QUALITY ASSURANCE -- NON-CONFORMANCE REPORT

Report No: NCR-000530

Reference Description: I-Rib components for Segment 5AW were welded in a misaligned position

Job Name: SAS Superstructure

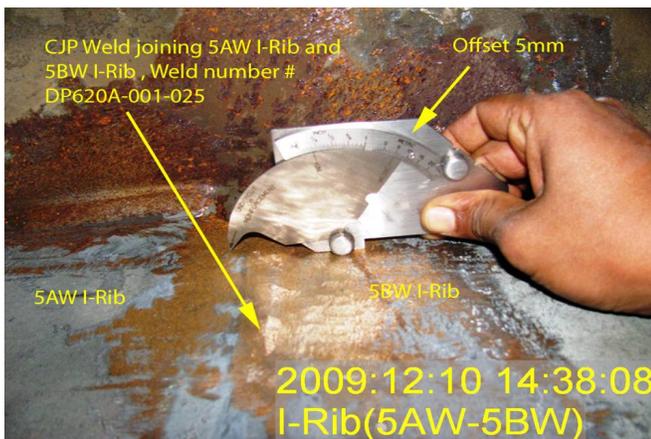
The Caltrans Quality Assurance (QA) Inspector observed an I-Rib weld between 5AW to 5BW Crossbeam side (W5) that was misaligned and welded. The out of tolerance offset measurement across the weld is 5mm and the maximum allowed per AWS D1.5 2002 is 3mm.

The weld is identified as: DP620A-001-025

The weld is a Complete Joint Penetration (CJP) butt weld.

The location of the weld is between 5AW I-Rib to 5BW I-Rib, Cross beam side at W5.

AWS D1.5 (02) Section 3.3.3; "Parts to be joined by groove welds shall be carefully aligned. Where the parts are effectively restrained against bending due to eccentricity in alignment, the offset from theoretical alignment shall not exceed 10 percent of the thickness of the thinner part joined, but in no case shall be more than 3 mm

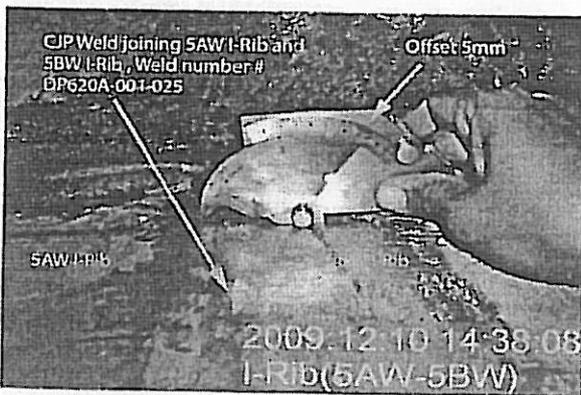
The Caltrans Quality Assurance (QA) Inspector observed an I-Rib weld between 5AW to 5BW Crossbeam side (W5) that was misaligned and welded. The out of tolerance offset measurement across the weld is 5mm and the maximum allowed per AWS D1.5 2002 is 3mm.

The weld is identified as: DP620A-001-025

The weld is a Complete Joint Penetration (CJP) butt weld.

The location of the weld is between 5AW I-Rib to 5BW I-Rib, Cross beam side at W5.

AWS D1.5 (02) Section 3.3.3; "Parts to be joined by groove welds shall be carefully aligned. Where the parts are effectively restrained against bending due to eccentricity in alignment, the offset from theoretical alignment shall not exceed 10 percent of the thickness of the thinner part joined, but in no case shall be more than 3 mm

SURVEY DATA FOR CORNER ASSEMBLY

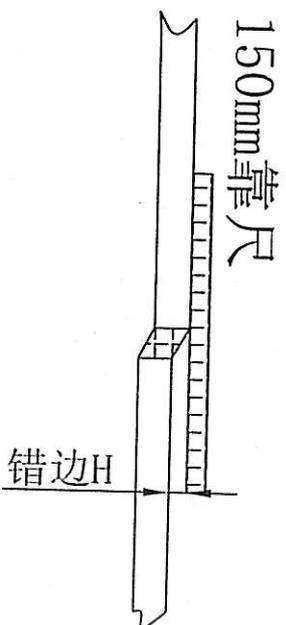
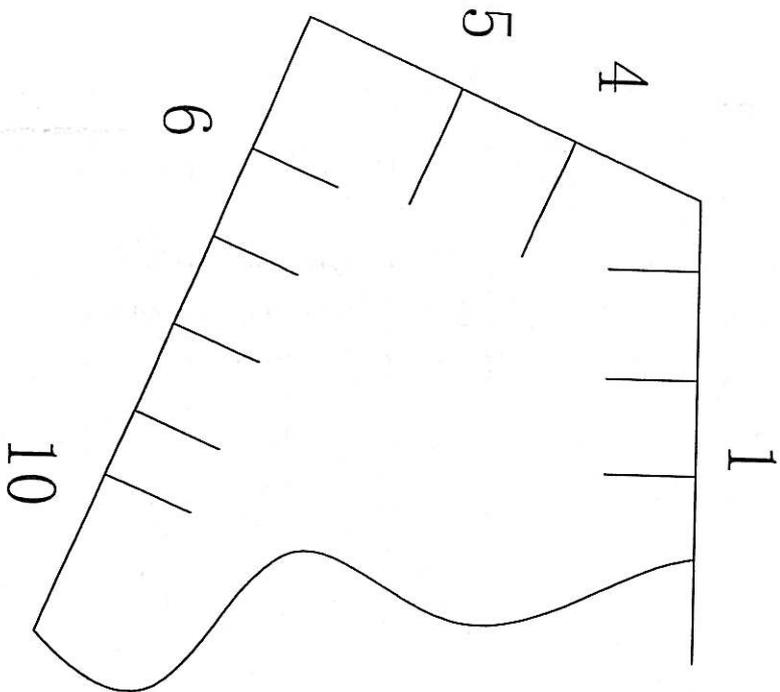
- After ZPMC's confirmation with CT the misalignment for this I-rib was measured to be 3mm what was acceptable.
- Punch List item 344 was closed basing on the measurement by CT.

Contractor supplied survey data showing that the misalignment was corrected and the members were brought within 3mm of each other. This issue was tracked by Voyage 2 Punchlist item no. 344 and was signed off 02-23-2010.
